# Access Compliance Report

## Public Rights-of-Way

Intersection ID: 5897	Main Street: FOREST_POND_DR	Cross Street: PINK_DOGWOOD_LN	Location: E
ADA ID: B379C24D6CBE	Ramp Type: Perp	Initial Pass/Fail: Fail	Overall Compliance: No
Severity Score: 10			
Codes/Mitigation Info/Possible Solution		Field Measurements/Component Compliance

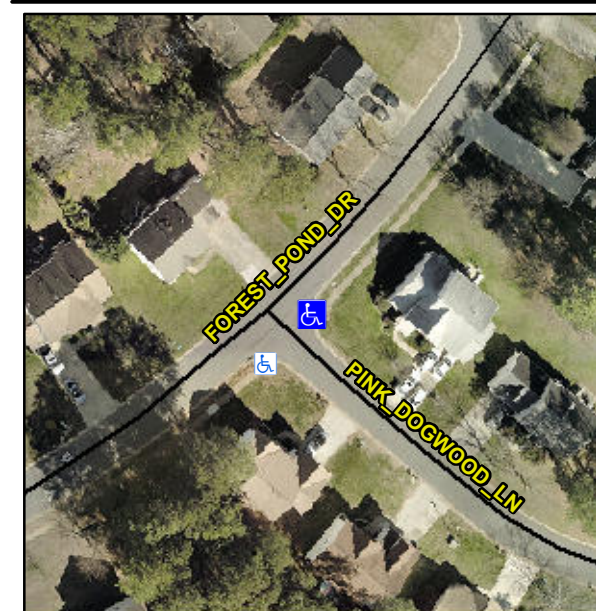
**Not Found, R304.5.1, R304.5.3**

Compliance	Description	Data	Compliance	Description	Data
N/A	Ramp Length (in)	95.0	Yes	Ramp Slope (%)	5.8
No	Ramp Width (in)	42.0	No	Ramp XSlope (%)	2.8
N/A	Flare Type LT	N/A	N/A	Flare Type RT	N/A
N/A	Flare Slope LT (%)	N/A	N/A	Flare Slope RT (%)	N/A
N/A	Flare Traversable LT?	N/A	N/A	Flare Traversable RT?	N/A
N/A	Landing Length (in)	N/A	N/A	DWS Provided?	N/A
N/A	Landing Width (in)	N/A	N/A	DWS Contrast?	N/A
N/A	Landing Slope (%)	N/A	N/A	DWS Length (in)	N/A
N/A	Landing X Slope (%)	N/A	N/A	DWS Full Width?	N/A
N/A	Landing Curb? (Y/N)	N/A	N/A	DWS Offset (in)	N/A
N/A	Shared Landing?	N/A			
N/A	Gutter Ponding?	N/A	N/A	Gutter Slope (%)	N/A
N/A	Gutter Lip Ht (in)	N/A	N/A	Gutter X Slope (%)	N/A
N/A	Painted X Walk1?	No	N/A	Painted X Walk2?	N/A
	X Walk 1 Direction	To SW		X Walk 2 Direction	N/A
N/A	X Walk 1 Width (in)	N/A	N/A	X Walk 2 Width (in)	N/A
	X Walk 1 Slope (%)	0.6		X Walk 2 Slope (%)	N/A
	X Walk 1 X Slope (%)	4.5		X Walk 2 X Slope (%)	N/A

**Remove & Replace Entire Ramp.**
